The previously provided comments have been addressed. The following answers to the comments from the review of the revised documents are shown in bold:

**Figure 13-24. Micropool Extended Detention Pond Schematic**

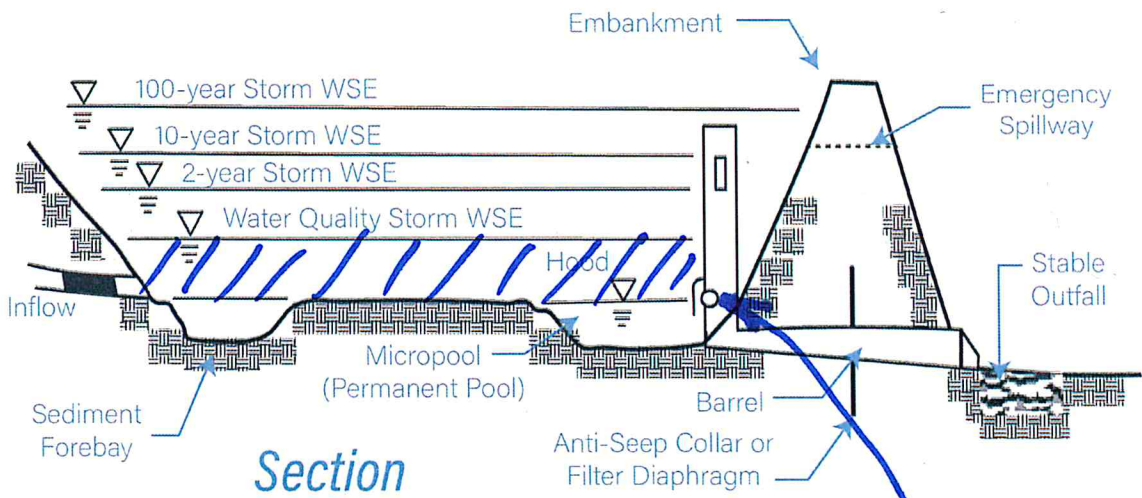
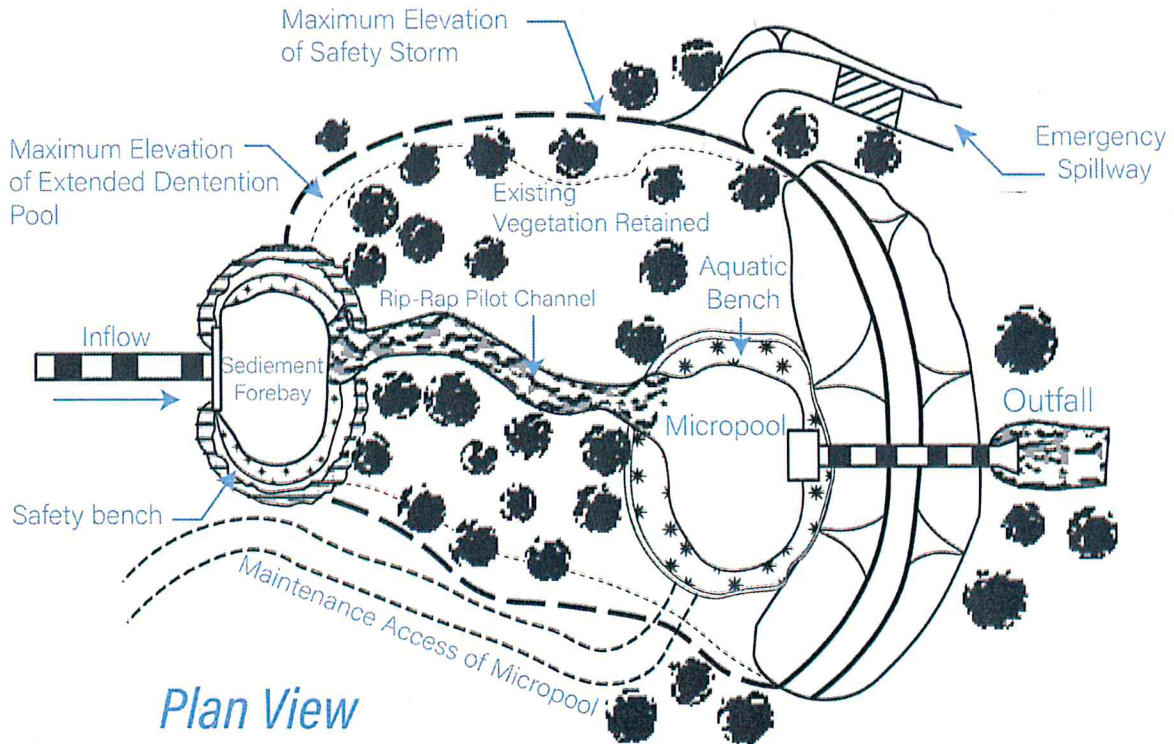
- It appears that storage volume above the low-level outlet is being counted towards the water quality volume storage provided by the forebay and water quality basin. Please verify that the reported water quality volume storage only includes the volume below the low-level outlet.

**The water under the low-level outlet is a permanent pool, and will not be WQV. The water above the low-level outlet will be the WQV, in accordance in the attached Schematic plan from the new Manual.**
